**MEETING OF THE
PLANNING AND ZONING BOARD
QUASI-JUDICIAL PUBLIC HEARING**

March 1, 2016

Approval for a new multi-family dwelling for "Atlantis of Bay Harbor" located at 1170 103 Street, Lots 6 & 7 of Block 5. The developers are proposing to construct a thirty (30) unit mid rise residential development. The proposed units range from 1,275 to 2,260 sq. ft. The proposed design incorporates one squared shaped building positioned on top of a parking garage structure depressed 3'-6" below grade . The building is 6 stories in overall height (5 floors of residential over 1 floors of parking garage and lobby @ 65ft above BFE. The developer will be required to obtain 13 Transfer of Development Rights (TDR). Enclosed please find the site plan, elevations and landscape drawings. (Item #1A)

Subject: Site Development Plan Application
Atlantis of Bay Harbor – 30 DU Multi-family Residential Complex
1170 103rd Street
Bay Harbor Islands Acct. No. MB2015-129
MMPA Acct. No. 01-0702-1005

SITE PLAN
SCALE: 3/32" = 1'-0"

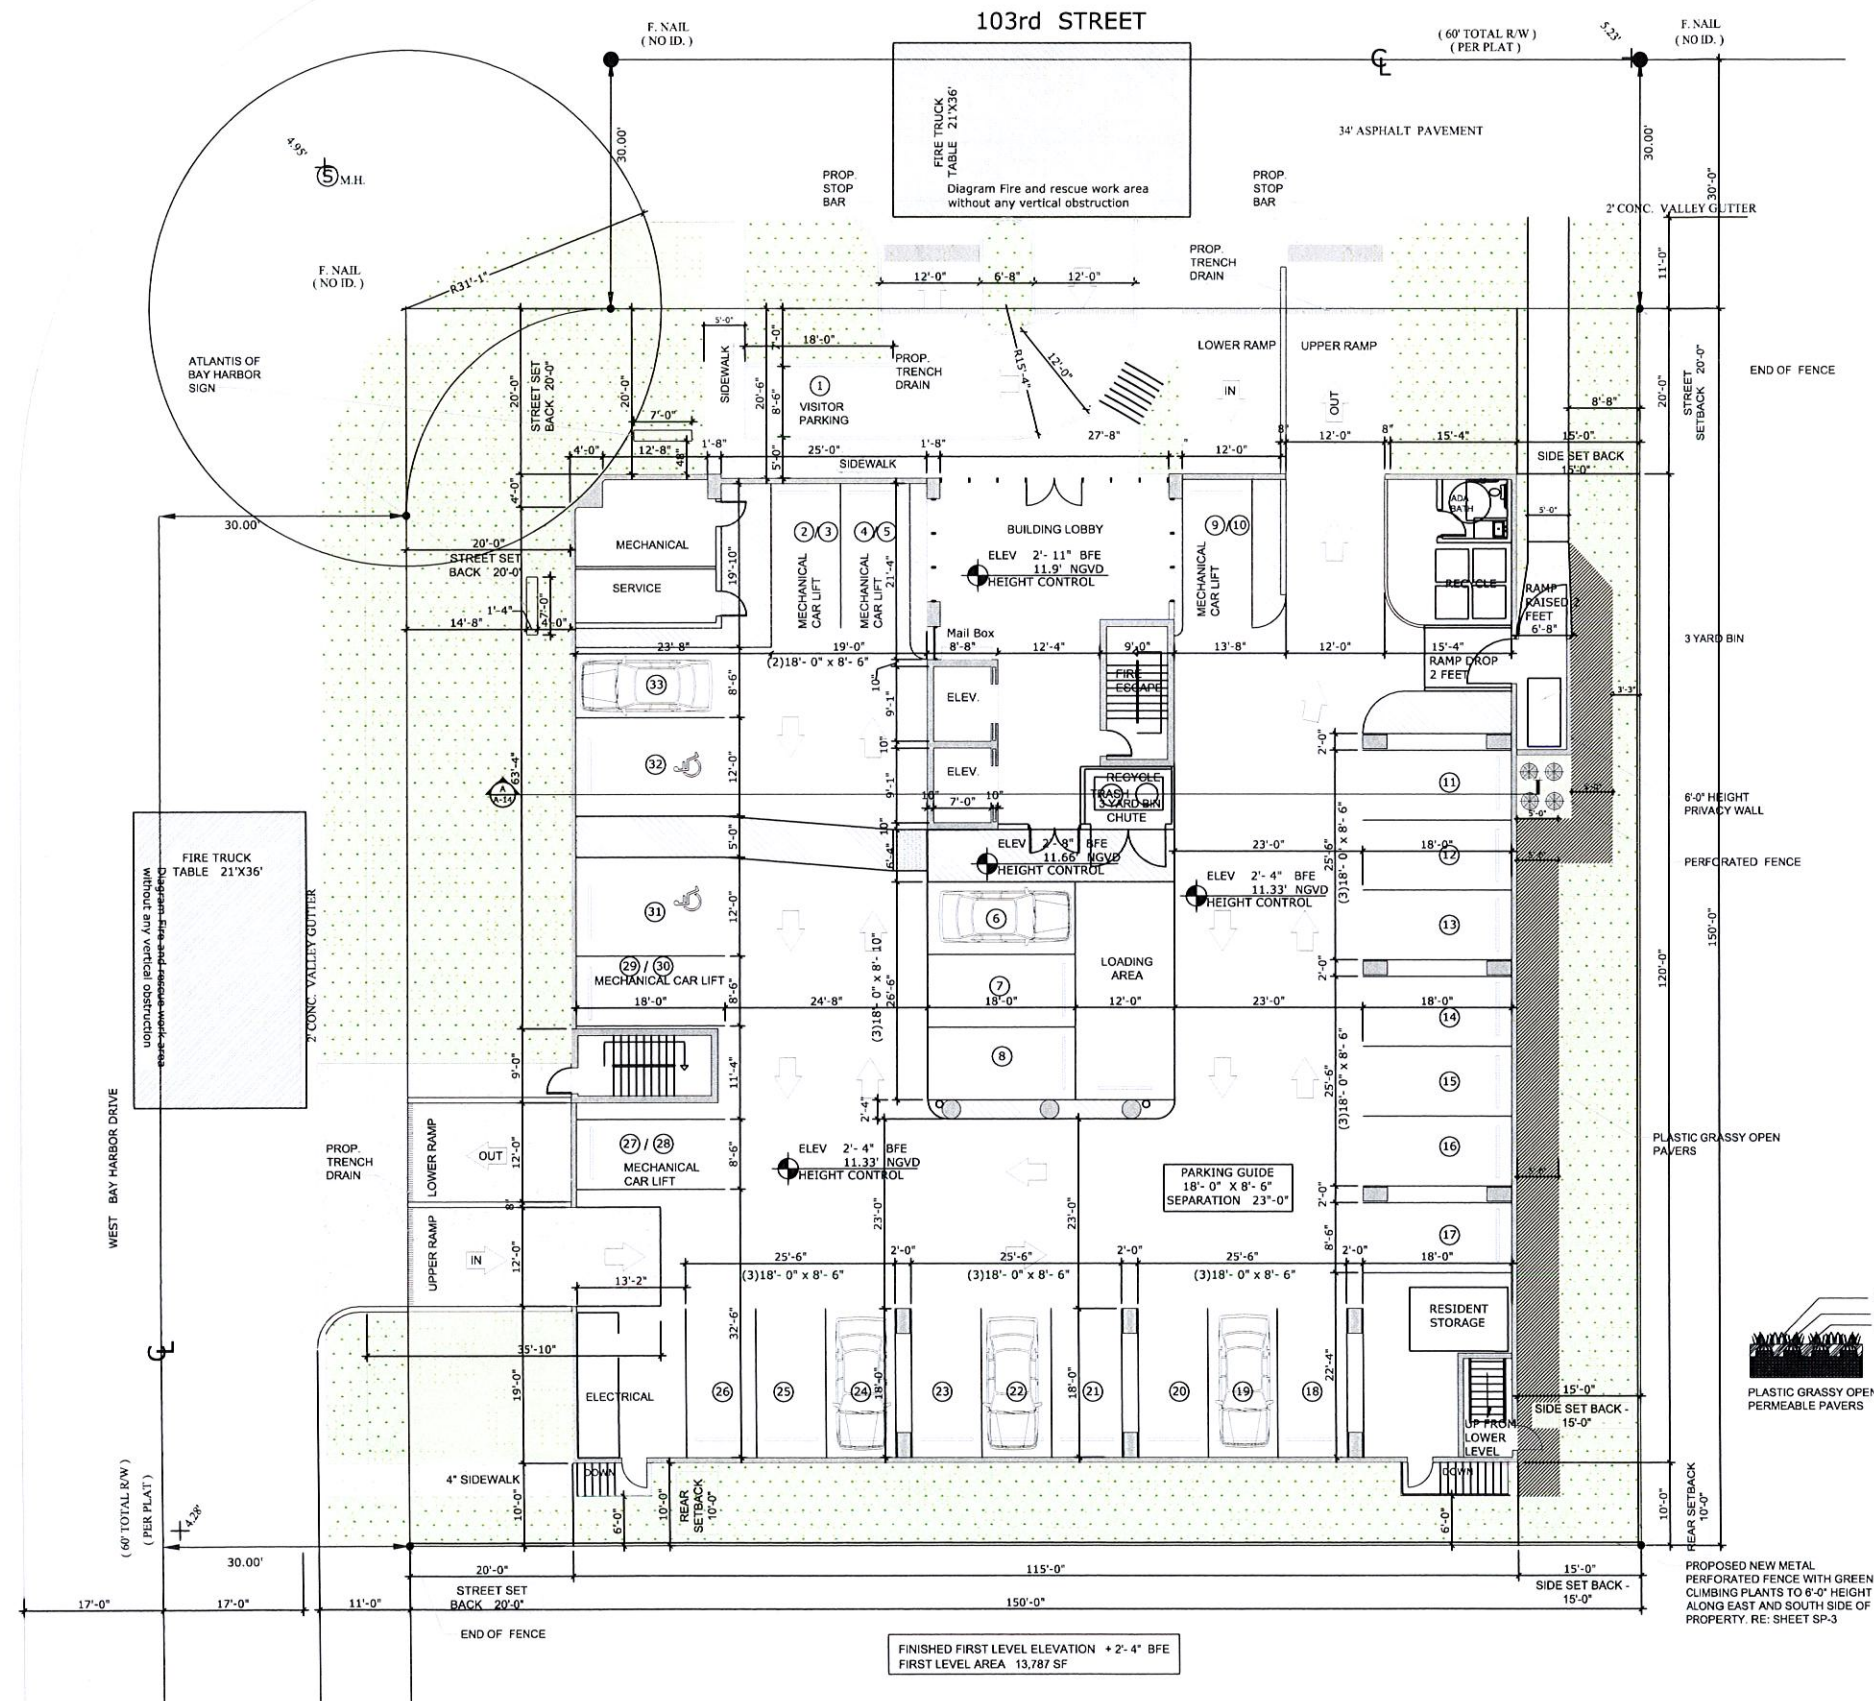
- 3) The applicant is requesting permission to reduce the normal 10-foot wide front-yard landscape strip to 7 feet (Miami-Dade County minimum) for the drop-off / guest parking space in the front yard area along 103rd Street. The Town Code allows a dimensional reduction as low as 7 feet if the Town approves the site design. Due to the small lot sizes and desire to include guest spaces and drop-off areas the Town has allowed this on numerous occasions. Planning and Zoning Board approval is required.

- 4) The applicant is requesting permission to provide one of the two required guest parking spaces in the lower level garage near the elevators rather than the front yard area. The Town Code allows the Planning and Zoning Board to approve alternate locations. Planning and Zoning Board approval is required.
